# PREVOST

## WARRANTY BULLETIN

**WB15-39**

DATE :	OCTOBER 2015	SECTION :	18 - BODY
EXPIRATION:	OCTOBER 2017		
SUBJECT :	H3 VIP Entrance Door Improvement

Fig.1

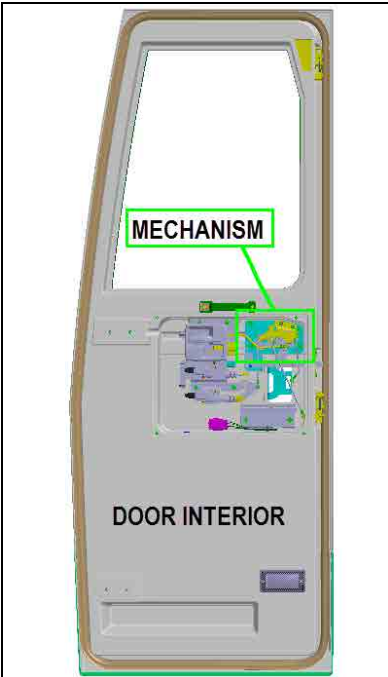
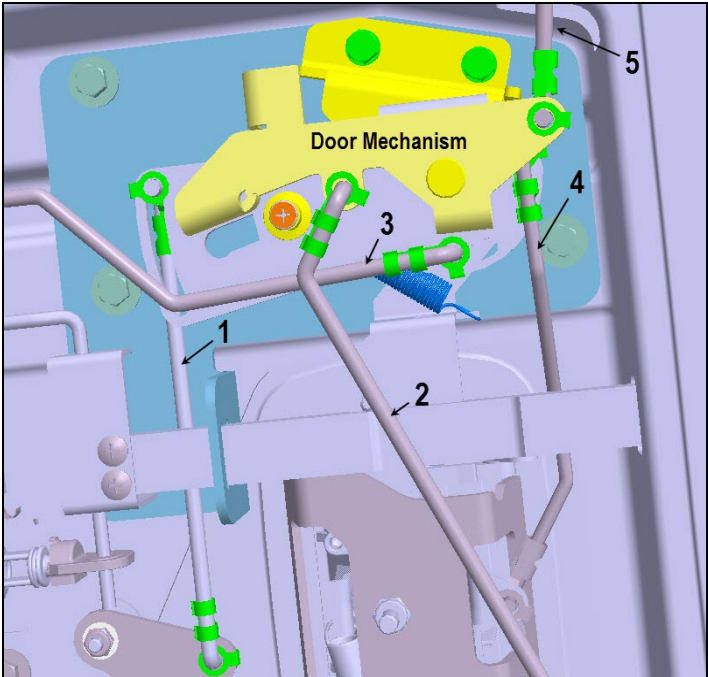
- 1. Remove the door interior trim panel (This operation will vary from vehicle to vehicles depending on their configuration).
- 2. Locate the door locking mechanism and the five actuating rods connected to it (see Fig.1 and 2 below).

- 3. Disconnect rods # 2, 3, 4 and 5 identified above at the *door mechanism* end of the rods.

Fig.3

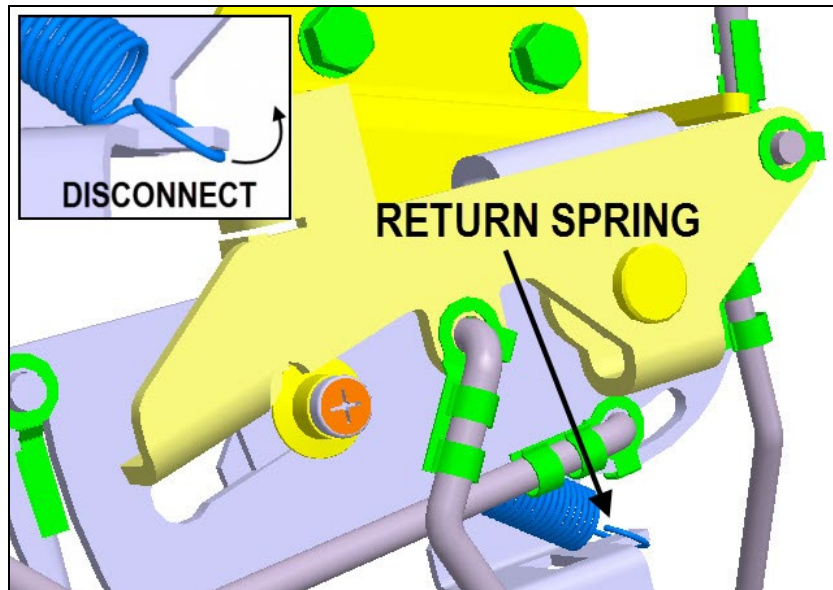
4. Remove and discard the vertical actuating rod (# 1) and *reinstall the two clips* on the new vertical rod included in kit WB15-39.
5. Disconnect the mechanism return spring (Fig.3).

Fig.4

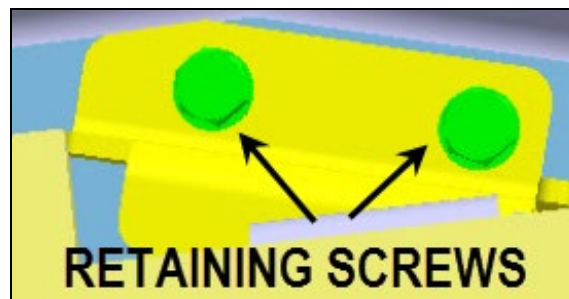
6. *Partially* unscrew (about half way) the two mechanisms retaining hex screws (Fig.4).

Fig.5

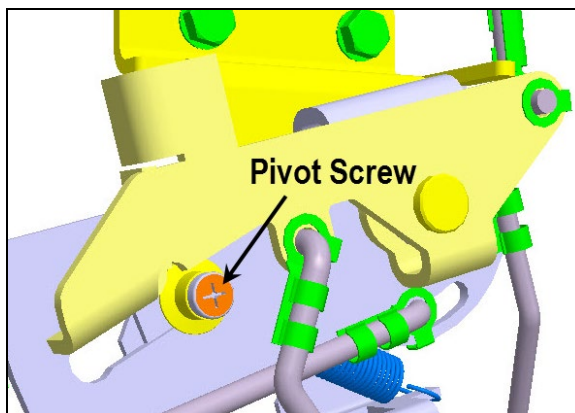
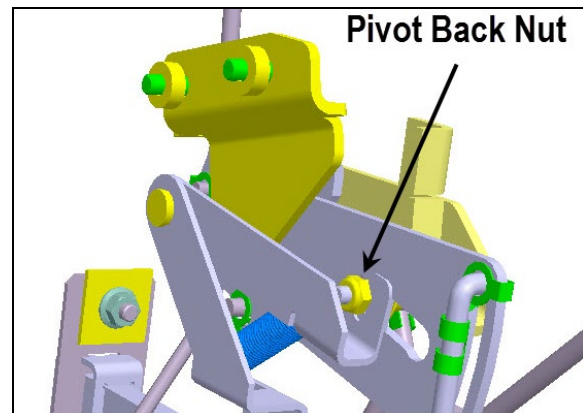
7. Unscrew the mechanism pivot screw (Phillips head shown on Fig.5), use an open end key or other suitable tool to hold the pivot backing nut (Fig.6).

Fig.7

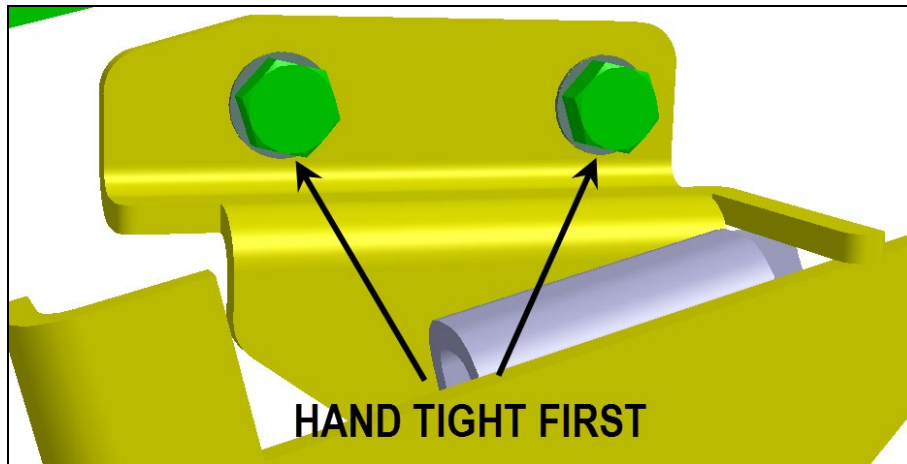
- Remove the two retaining bolts still holding the mechanism and remove it from the vehicle.
- Install the new mechanism on the vehicle door by first hand tightening the two retaining screws (Fig.7).

Fig.8

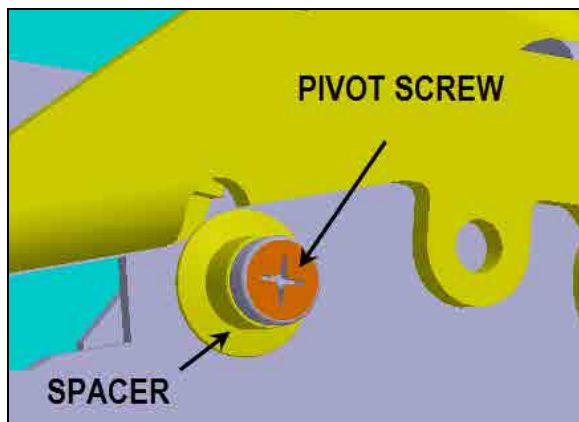
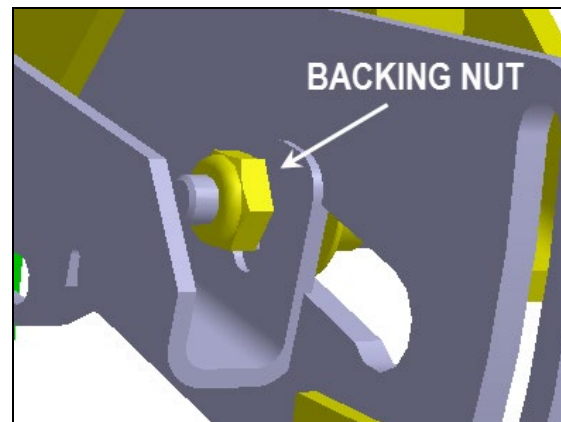
- Tighten the pivot screw Fig.8 (with spacer and backing nut Fig.9).

Fig.10

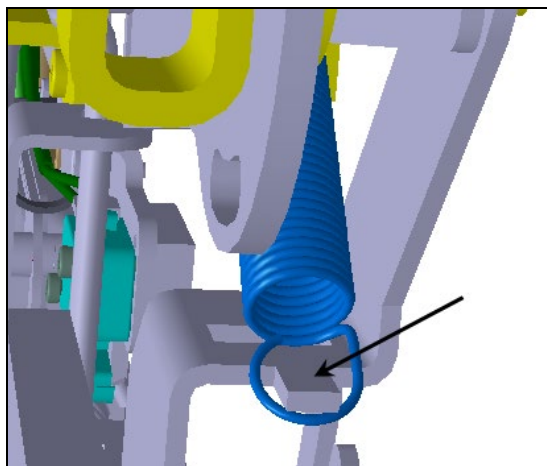
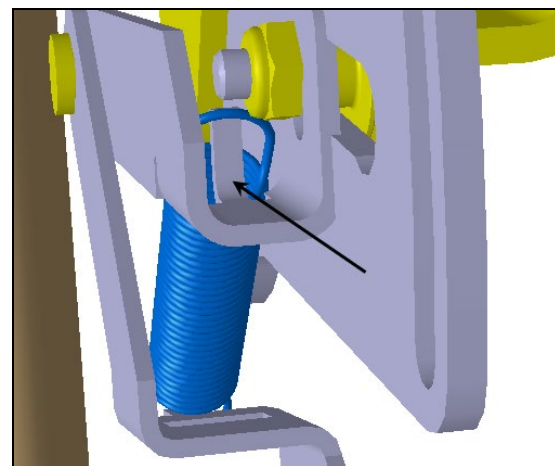
- Reinstall both ends of the return spring (Fig.10 and 11) *and tighten the two retaining screws.*

Fig.12

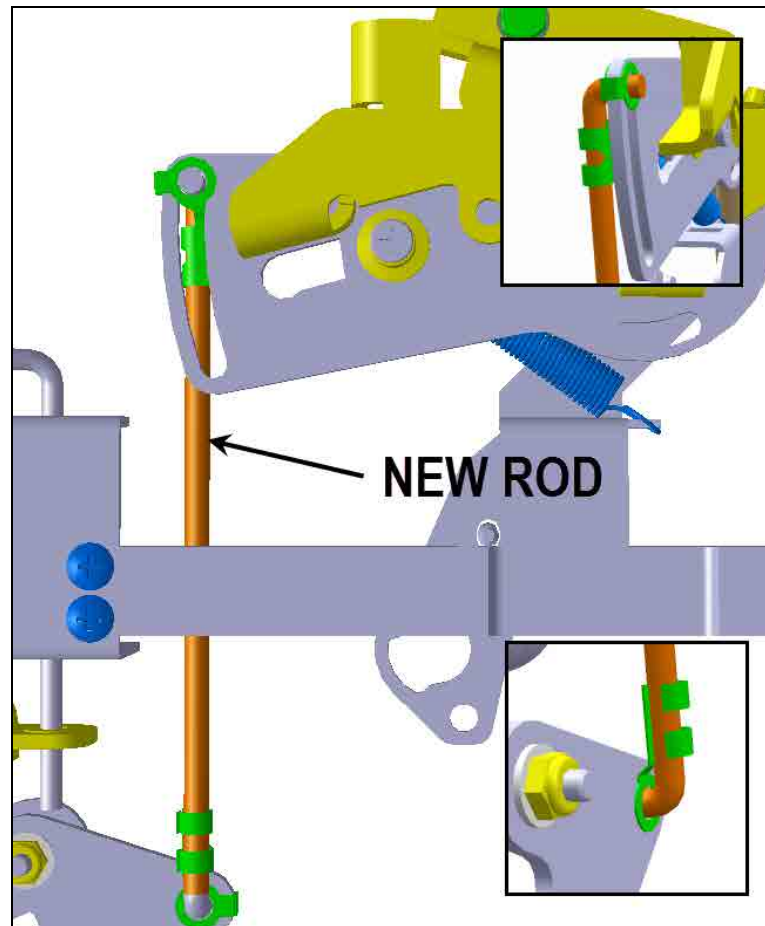
12. Install the new vertical actuating rod previously fitted with retaining clips (Fig.12)

Fig.13

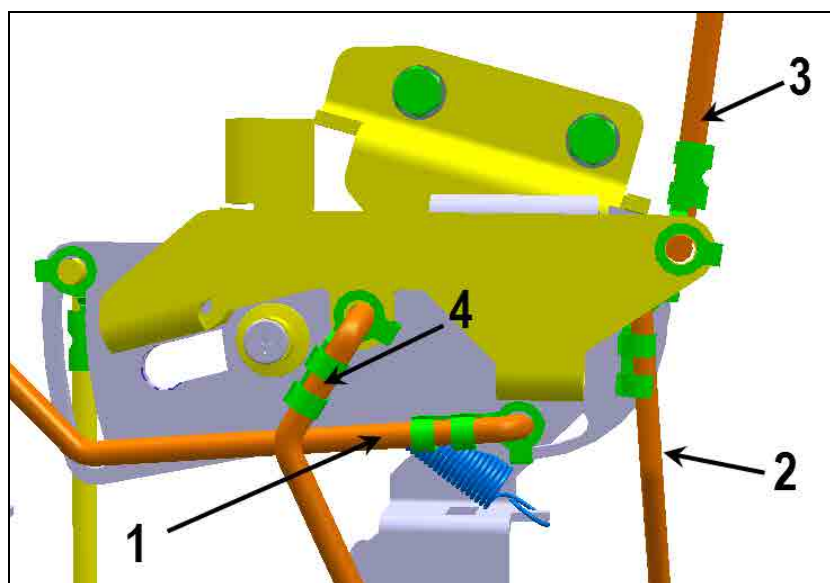
13. Reconnect the four remaining rods to the mechanism in the order shown below (Fig.13).
